SERVICE CAMPAIGN BULLETIN

XL SERIES S-CAM LUBE CAMPAIGN

CAMPAIGN NO: T0420

SUBJECT VEHICLES: Certain XL Series trucks equipped with Drum Brakes.

Rear Axle

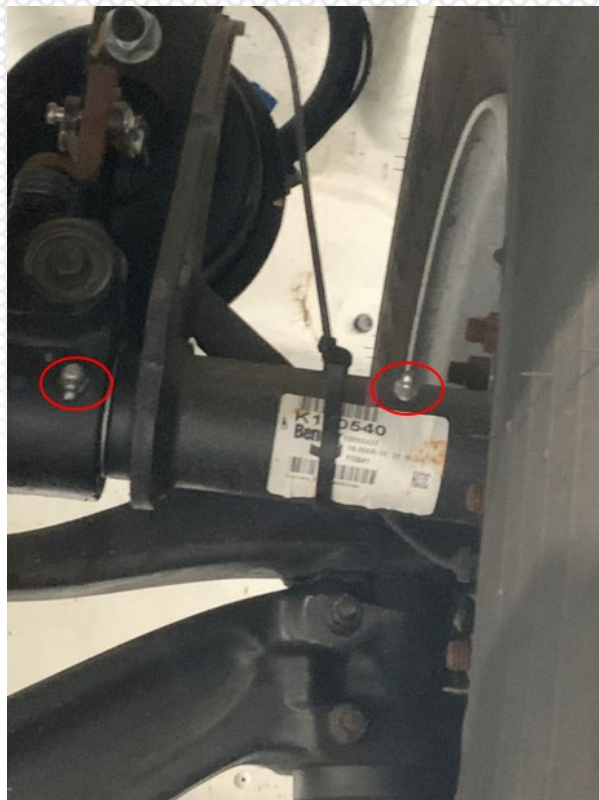
XL Series trucks equipped with a Dana front and rear drum brakes. During inspection, we found a few of the Dana axle S-Cam tubes that were not initially greased from the factory. Please make sure the zerk fittings have been properly greased before releasing the truck.
